REMARKS**I. General**

Claims 1-23 are pending in the present application. Claims 1-2, 13-18, and 20-21 stand rejected under 35 U.S.C. § 102. Claims 3-9, 11, 12, 19, 22, and 23 stand rejected under 35 U.S.C. § 103. Claims 1-23 stand rejected under 35 U.S.C. § 112. Claims 2, 14-19, and 22 stand objected to because of informalities. The drawings stand objected to. Applicant respectfully traverses the rejections and objections of record.

FIG. 5
(PRIOR ART)

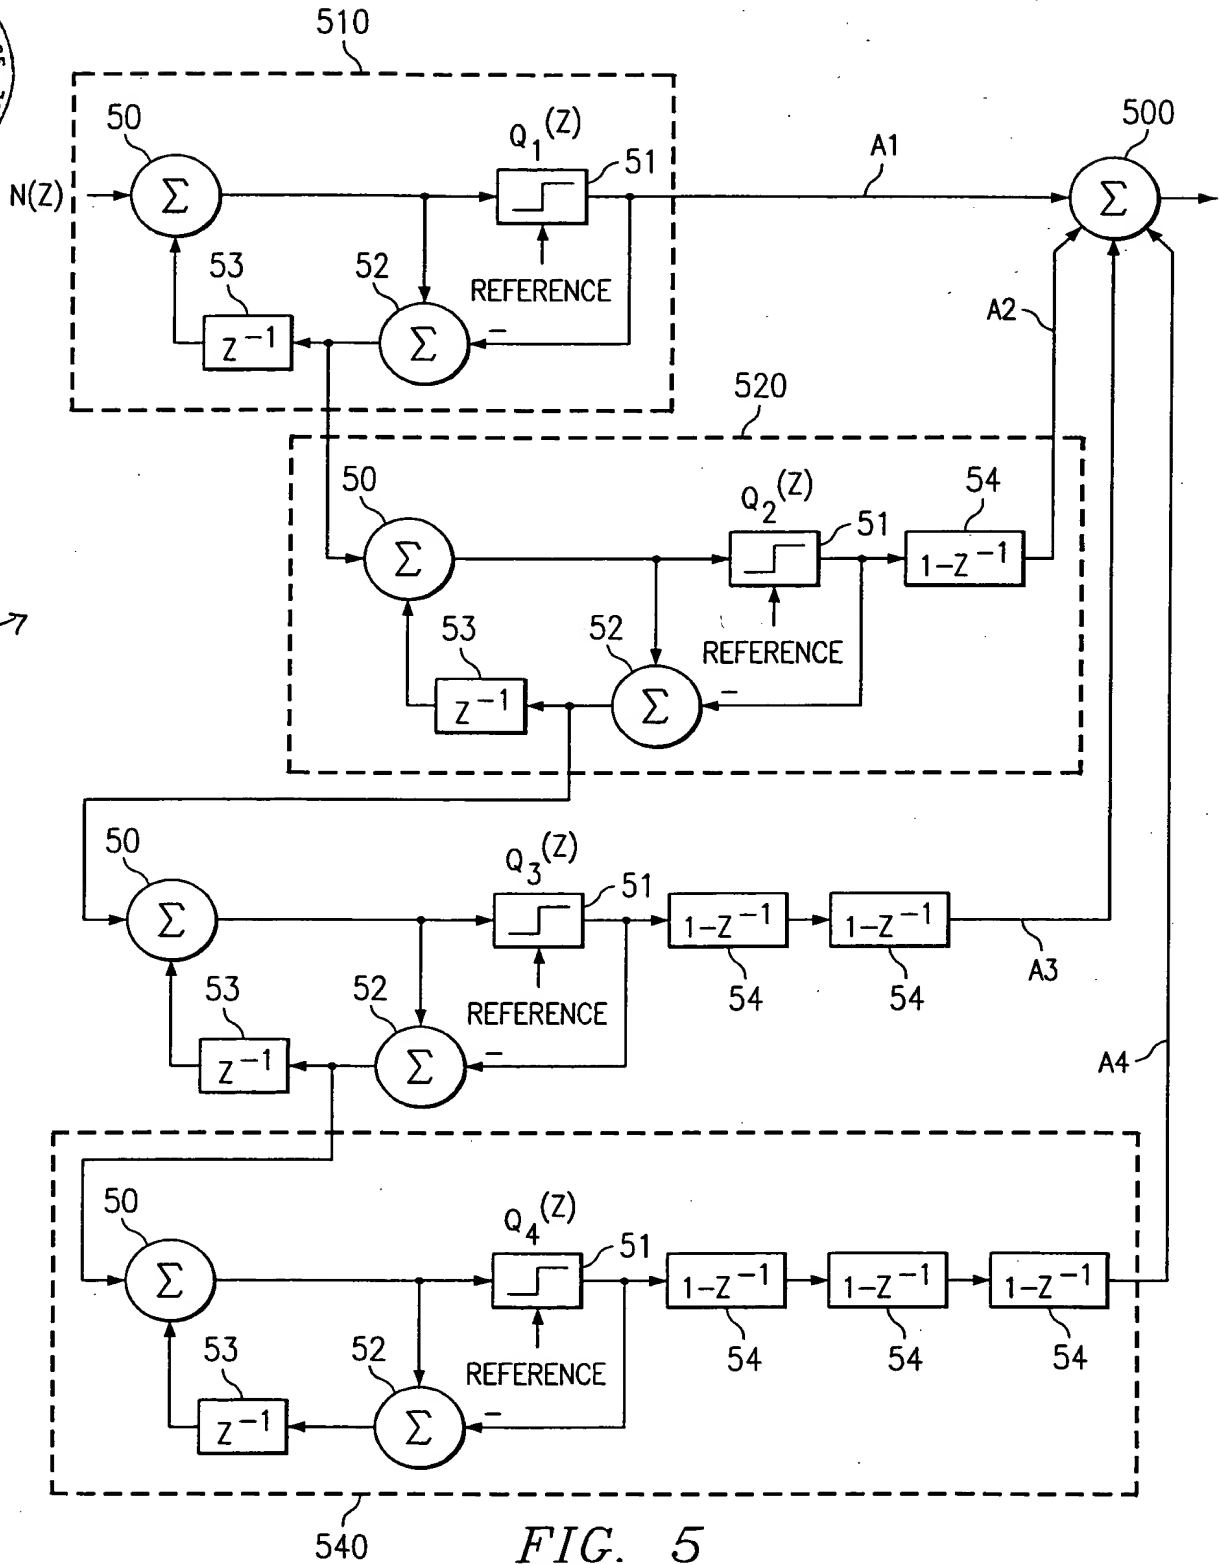
Figure 5 stands objected to as not including reference sign “5” as mentioned in the specification. Applicant submits herewith a proposed drawing amendment adding the reference sign to Figure 5.

FIG. 6

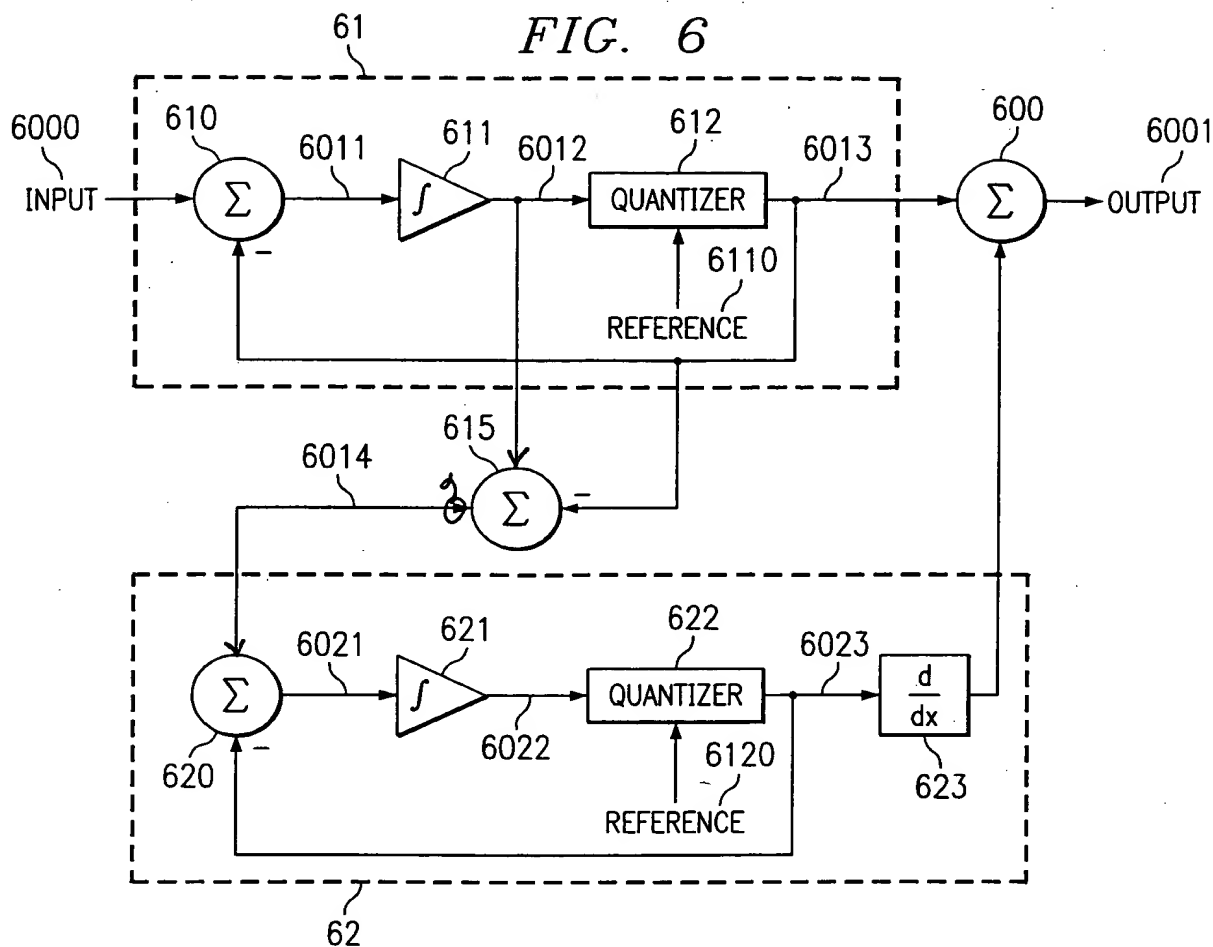
Figures 6, 7, and 8 have been amended to correct informalities discovered during the preparation of the present Amendment. In particular, lines connecting summers 615 and 620 of Figures 6, 7, and 8, summers 735 and 730 of Figures 7 and 8, summers 845 and 840 of Figure 8 included incorrect arrow heads in the formal drawings filed April 16, 2002. These figures have been corrected to correspond with the description provided at page 17, lines 17-25, page 18, lines 5-14, and page 18, line 26, through page 19, line 7. No new matter has been added.

FIG. 8

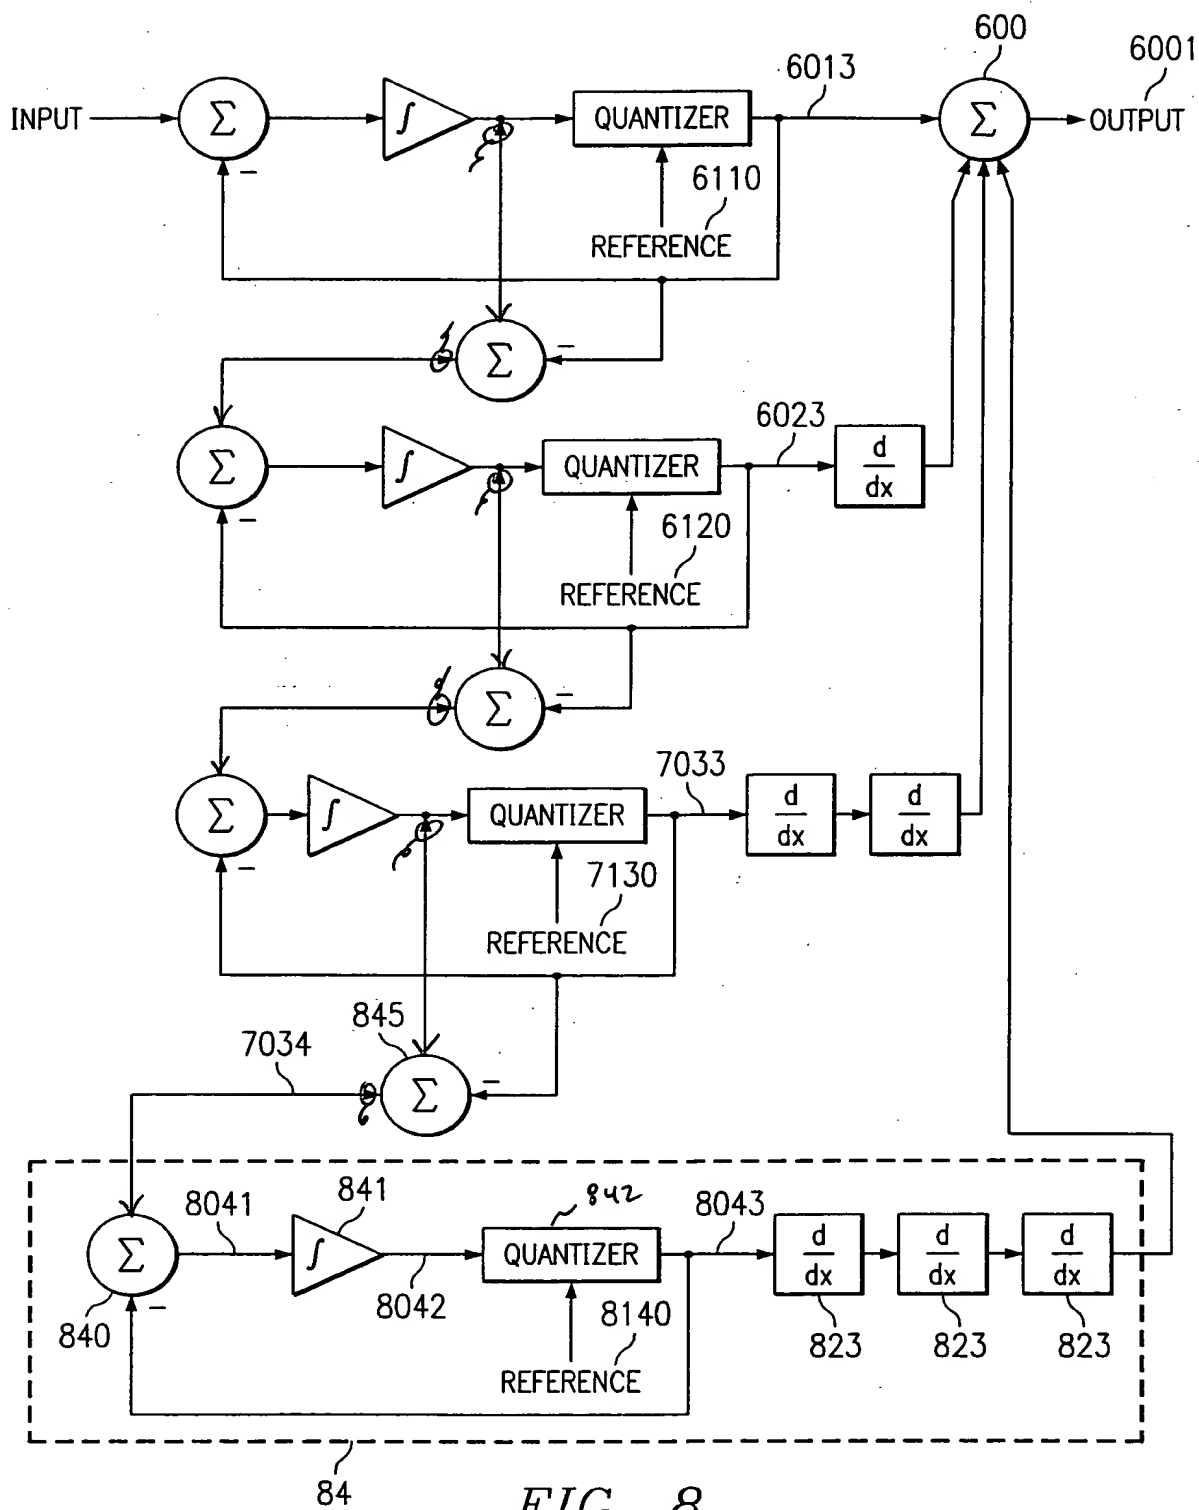
Figure 8 stands objected to as not including the reference sign “842” as mentioned in the specification. Applicant submits herewith a proposed drawing amendment adding the reference sign to the figure.

In rejecting claim 1, the Examiner asserts that the claim recites a set of differentiators disposed in each of said at least one subsequent stage but that Figure 8 shows a second stage which includes one differentiator only. It appears that the source of the Examiner’s consternation is recital of “a set of differentiators” when only one differentiator is shown with respect to a second stage. However, a set, in the ordinary and customary use of that term, can include a single element. As such, the language of claim 1 is fully enabled by the specification.

Figure 8 shows a first delta-sigma modulator comprising a one-stage delta-sigma modulator only. However, the disclosure of Figure 8 is not restricted to the Examiner's characterization of that figure. Figure 6 clearly shows a multi-stage delta-sigma modulator. Additionally, Figure 7 shows a multi-stage delta-sigma modulator wherein a delta-sigma modulator stage has been added to the delta-sigma modulator of Figure 6. Similarly, Figure 8 shows a multi-stage delta-sigma modulator wherein a delta-sigma modulator stage has been added to the delta-sigma modulator of Figure 7. Accordingly, it is clear from these figures that the first two stages of the multi-stage delta-sigma modulator of Figure 8 are themselves a multi-stage delta-sigma modulator and, likewise, the first three stages of the multi-stage delta-sigma modulator of Figure 8 are themselves a multi-stage delta sigma modulator. Accordingly, it is clear from the figures that a characterization Figure 8 is that a first stage thereof comprises a multi-stage delta-sigma modulator. As such, Applicant respectfully asserts that the claim is fully enabled by the disclosure. Moreover, as claim 10 is not rejected over the art of record, Applicant asserts that claim 10 should stand allowed.

In rejecting claim 20 under 35 U.S.C. § 112, first paragraph, the Office Action states that claim 20 recites means for providing the modulated output signal to an output of the multi-order delta-sigma modulator but no additional circuitry is shown other than the summing circuit 600 of Figure 8 for providing the modulated output signal to an output of the multi-order delta-sigma modulator. However, Figure 8 clearly shows output 6001 coupled to summing circuit 600 via a transmission line for providing the modulated output signal to an

output of the multi-order delta-sigma modulator. Applicant respectfully asserts that the claim is fully enabled by this disclosure.

FIG. 9

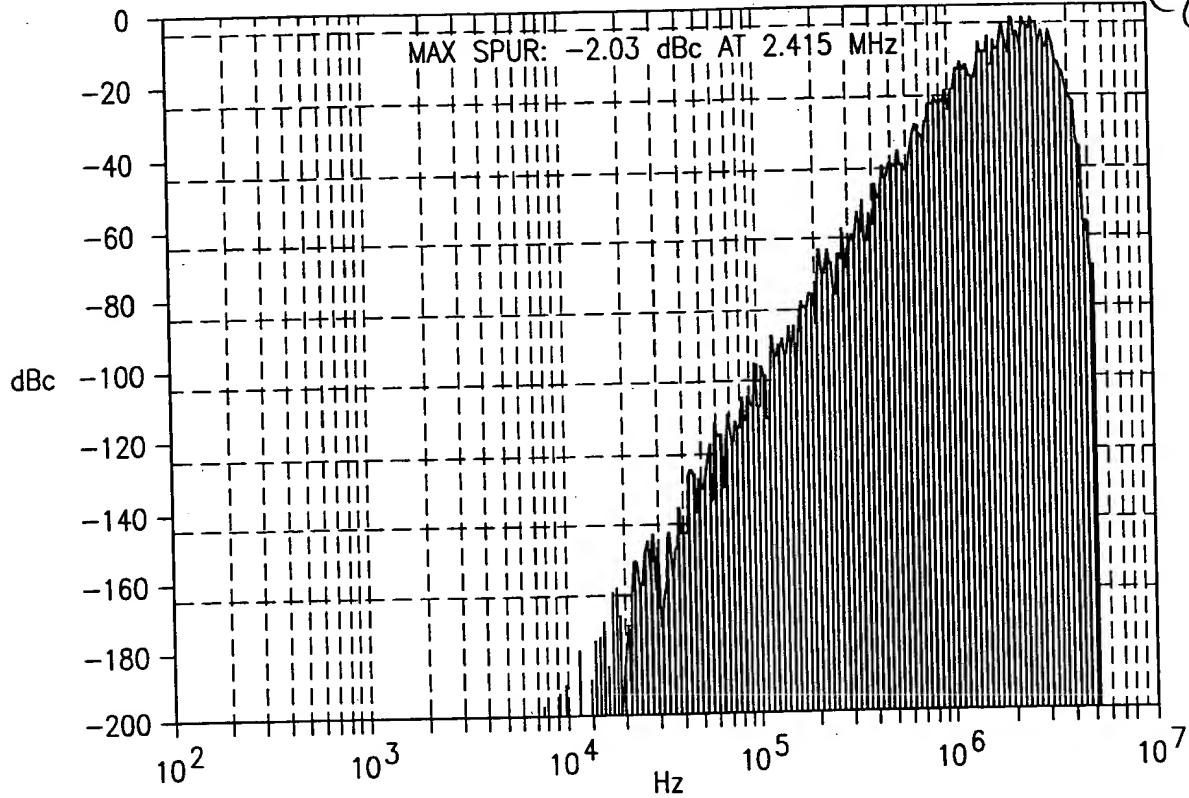
Figure 9 stands objected to as requiring the legend “Prior Art.” Applicant submits herewith a proposed drawing amendment adding the legend to the figure.
